IREDELL COUNTY HEALTH DEPARTMENT

IMPROVEMENT PERMIT / AUTHORIZATION TO CONSTRUCT / OPERATION PERMIT / EXISTING SYSTEM INSPECTION

PERMIT# 144157 PIN# 4635598014 DATE 7-27-07

LOCATION Brawley School Rd TL Stutts at corner of Southwood Park Address: 208 Southwood Park

INITIAL SITE SKETCH

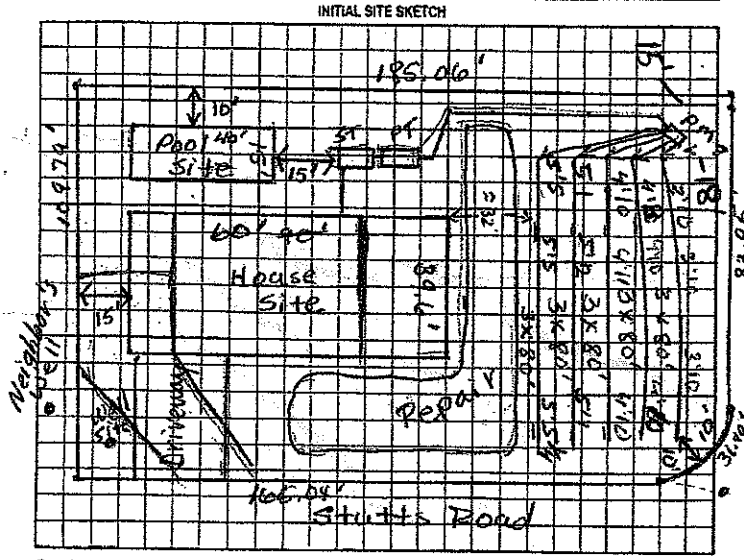
Comments/Conditions:
Mark corner radius of property line before installation
Well 50' setback from repair

AS BUILT SKETCH

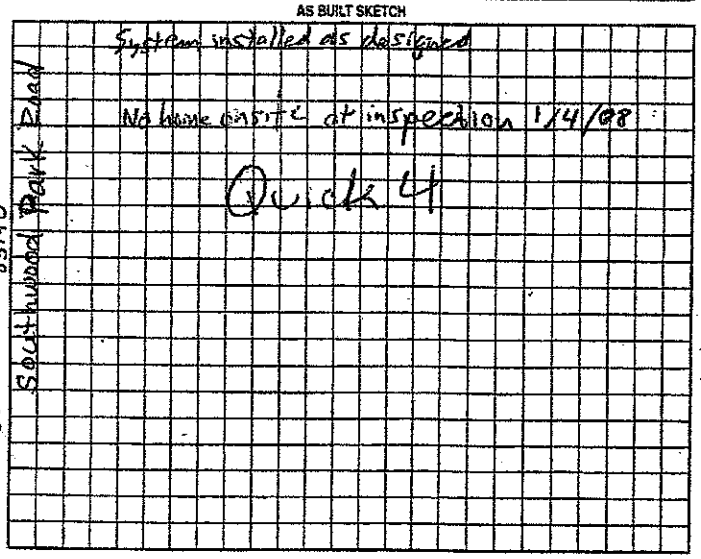
The location of the proposed Pool addition does not appear to impact the existing septic system.
**NOTE: Shall be min. 15' from septic tank
